**CITY OF WINTER PARK
PLANNING AND ZONING BOARD**

**Staff Report
March 6, 2018**

SPR 18-03 REQUEST OF WINTER PARK DESIGN FOR APPROVAL TO CONSTRUCT A NEW 5,758 SQUARE FOOT SINGLE-FAMILY HOME LOCATED AT 1234 LAKEVIEW DRIVE ON LAKE VIRGINIA, ZONED R-1AAA.

REQUEST OF VERAX INVESTMENTS, LLC FOR: CONDITIONAL USE APPROVAL TO CONSTRUCT A TWO STORY, 20,000 SQUARE FOOT MEDICAL AND GENERAL OFFICE BUILDING ON THE PROPERTY AT 1111 WEST FAIRBANKS AVENUE, ZONED C-3.

OPTION 1 - SITE PLAN WITH NOTES

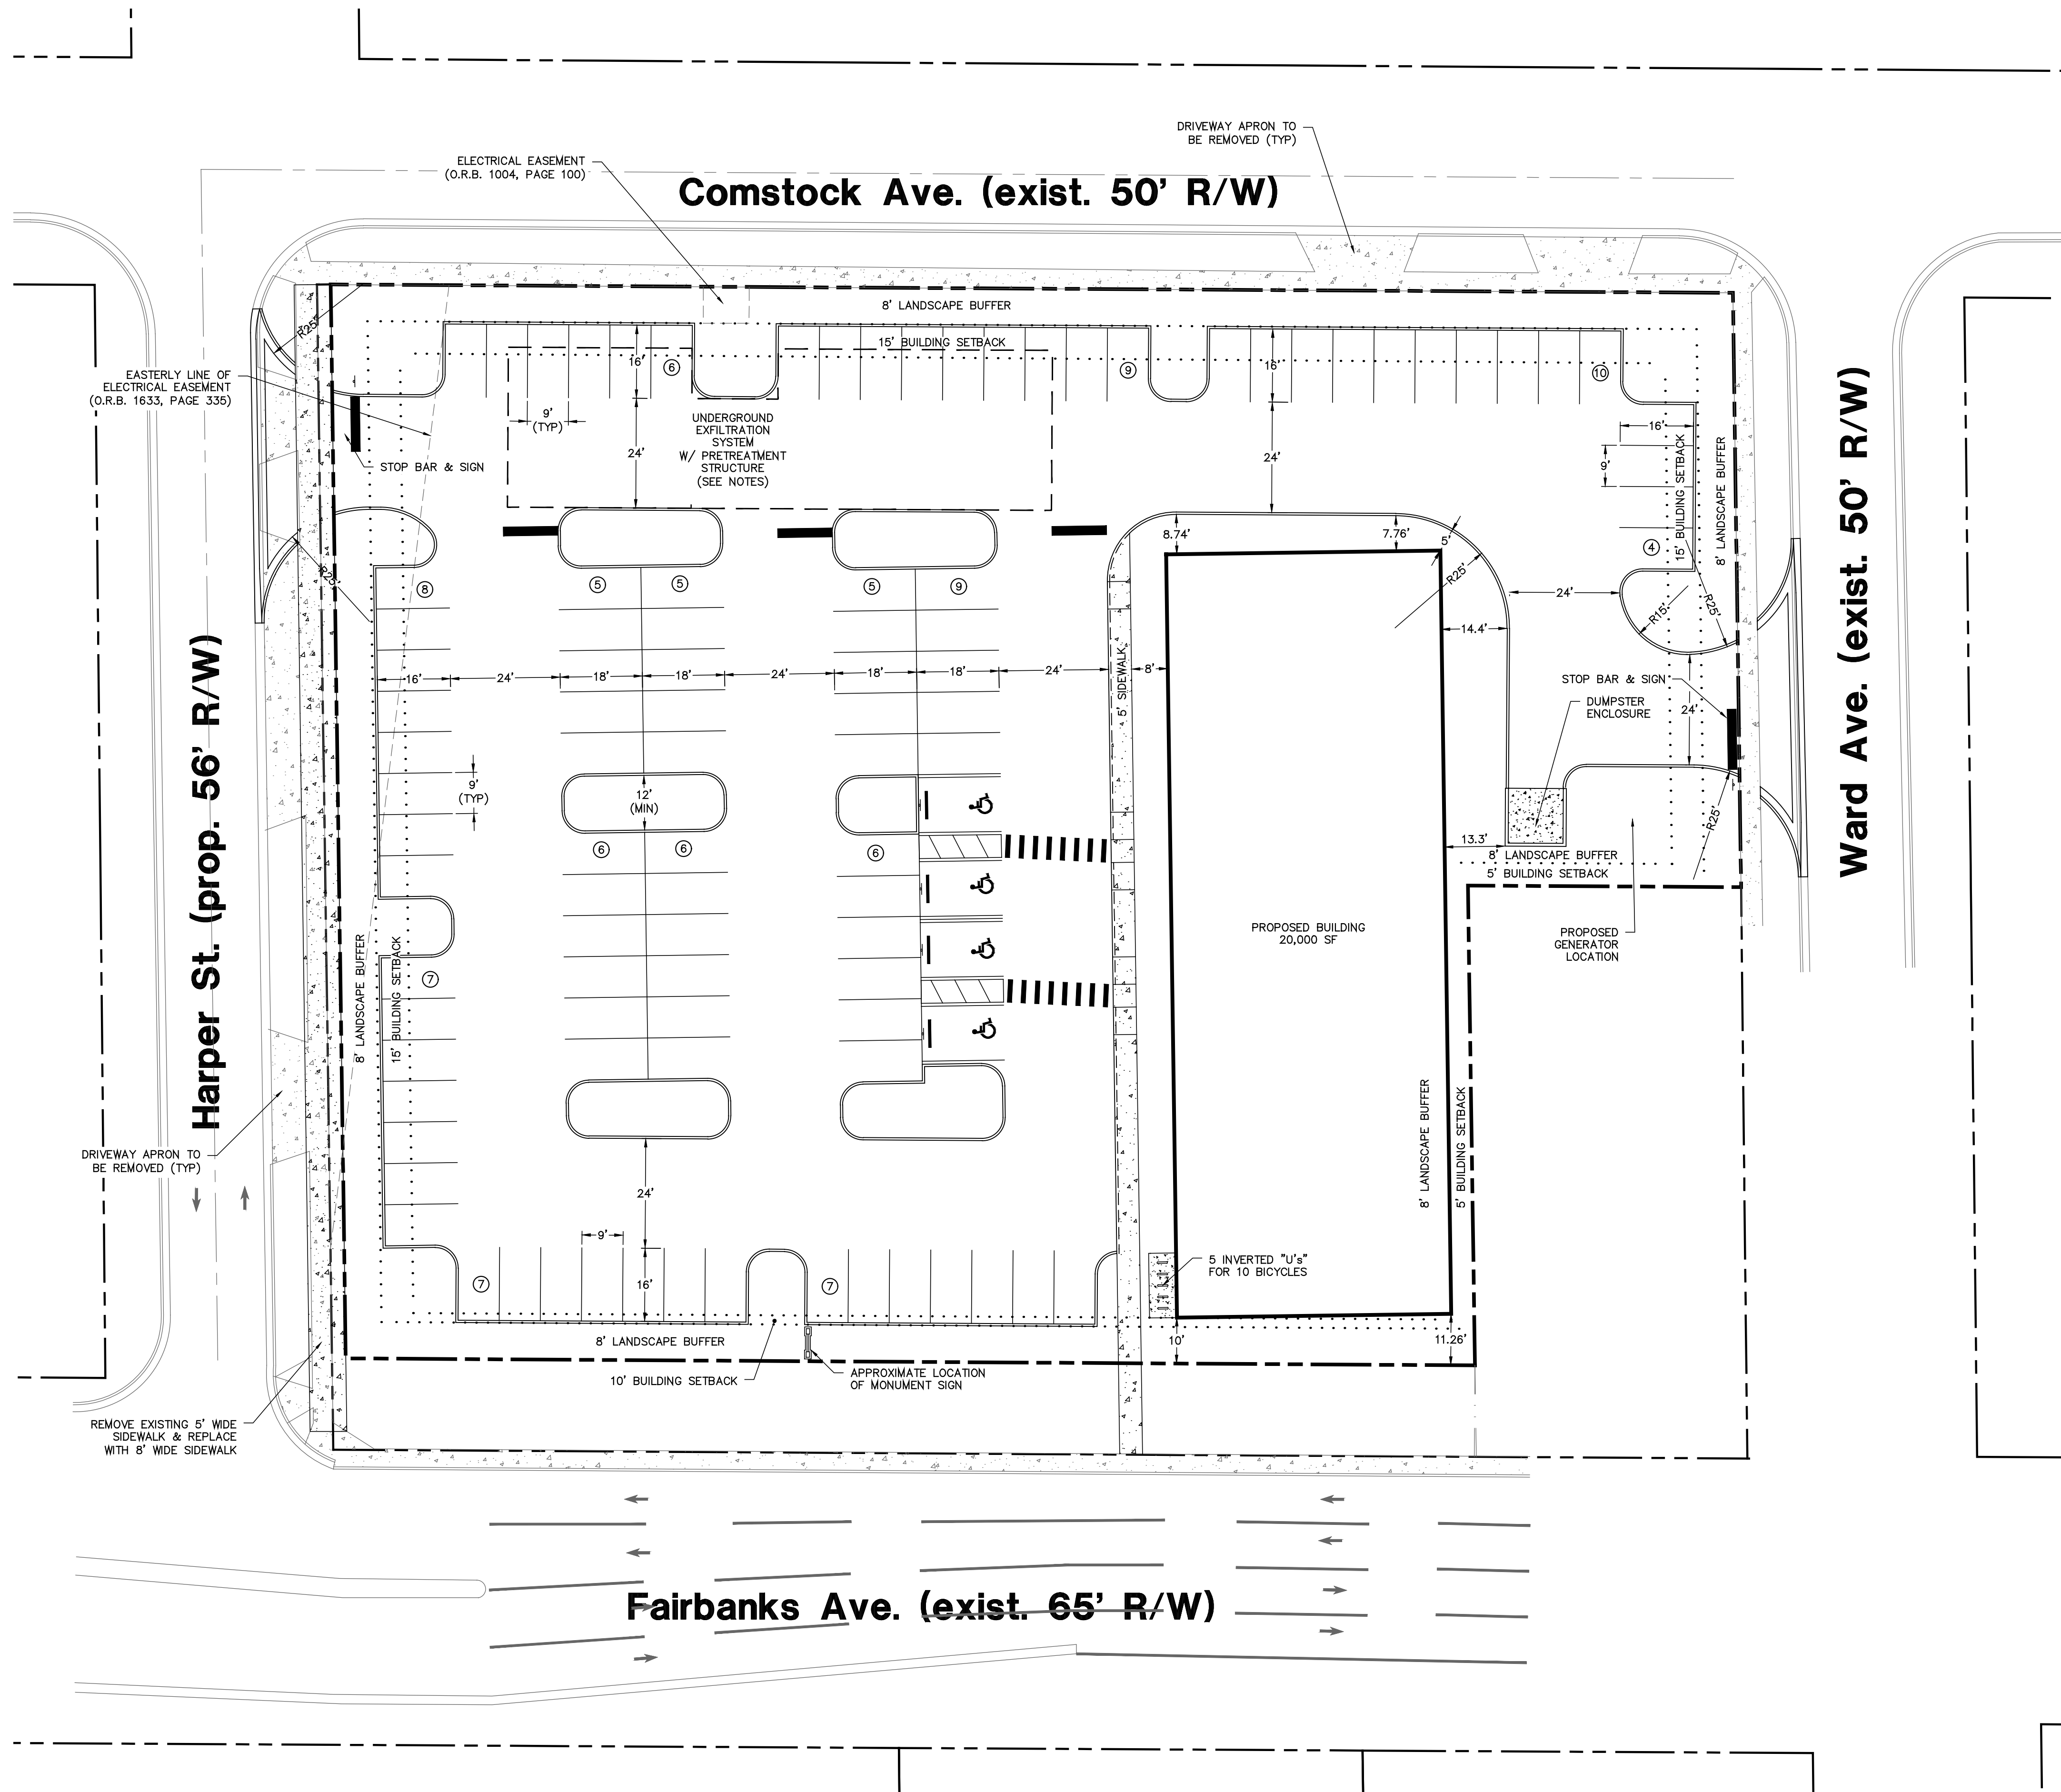
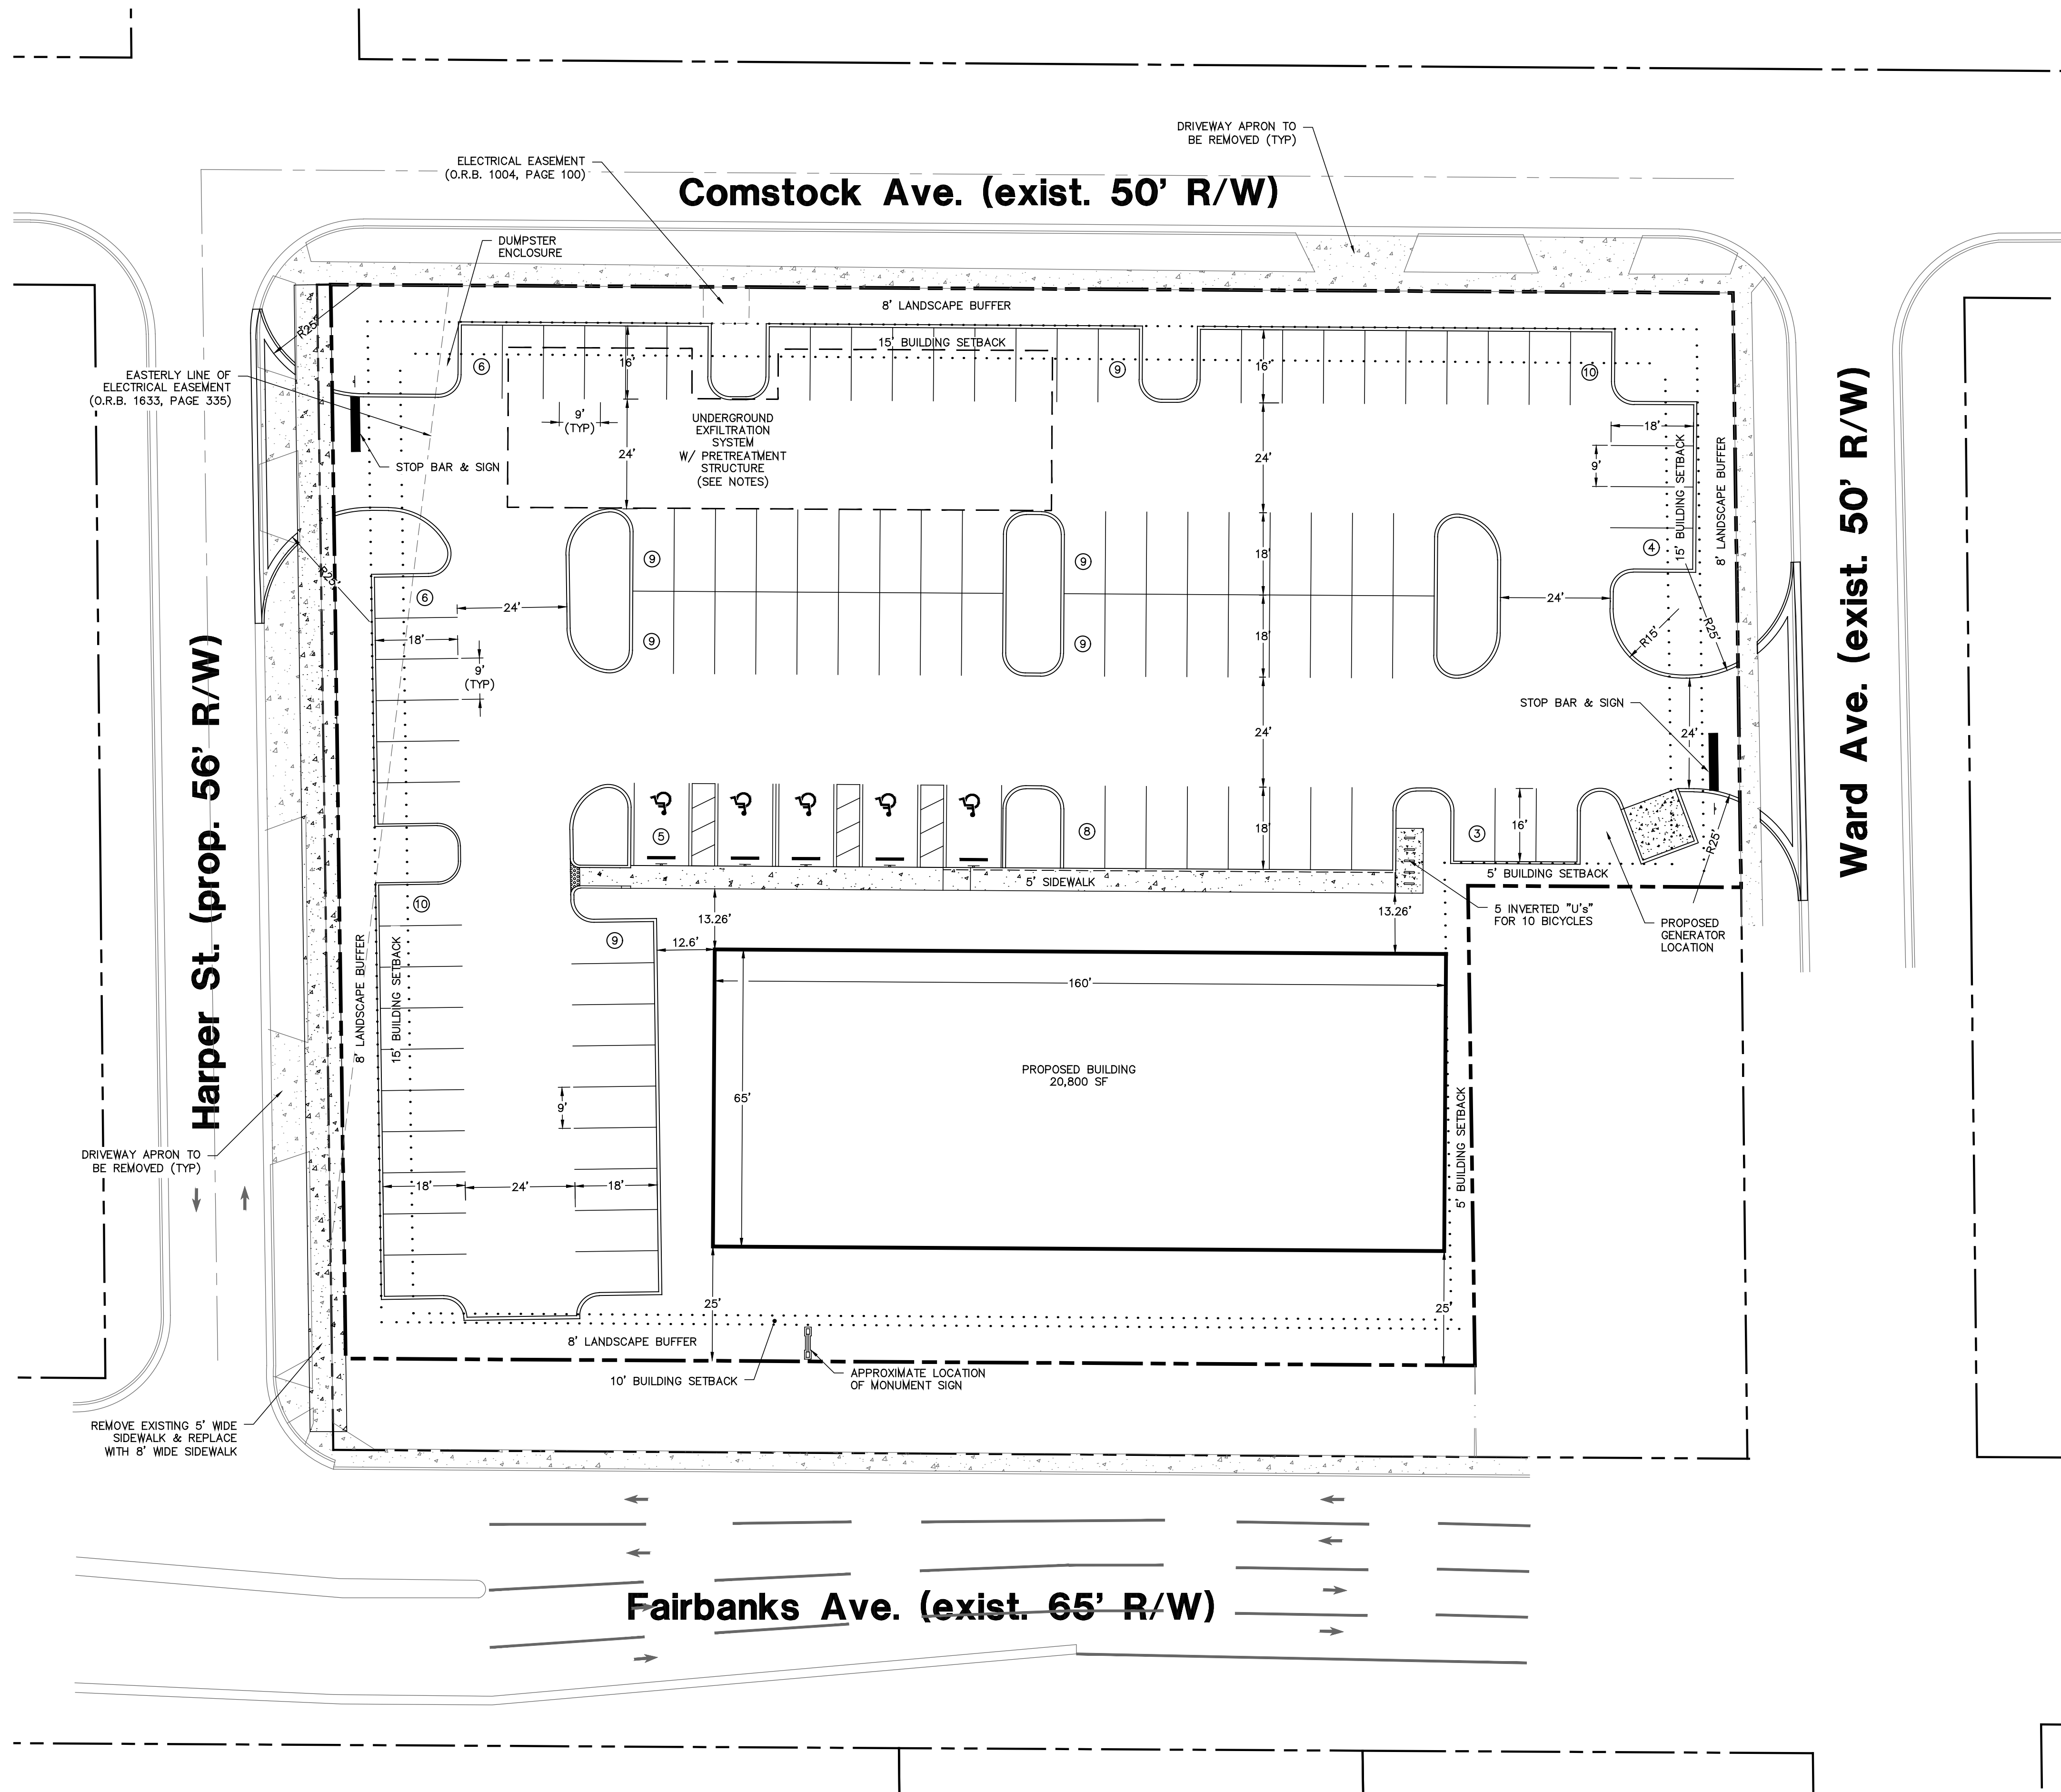
The applicant has provided two site plan options, both showing a two-story, medical/general office building. Option A is what was shown to the City Commission at the time this buyer was selected which locates the building in a north/south orientation on the eastern side of the property. Excluding the Harper Street right-of-way and Walgreens, it provides for a 165 foot view shed across the parking lot toward MLK Jr. Park. This option is approximately 20,000 square feet in size, has a floor area ratio (FAR) of 29% which is below the code maximum of 45%. This option meets all of the Code requirements with respect to building heights, setbacks, and impervious coverage.

There is a graphic in the applicant's materials concerning the view shed that attempts to conclude that both view shed options are similar. To be clear, the City Commission suggested, during the review of the NOD process, that the building should be located on the east side of the lot. This placement location was part of the overall contract for sale. The advantage of Option A is that it creates twice as much view shed (165 feet versus 80 feet) across the parking lot into MLK Jr. Park.
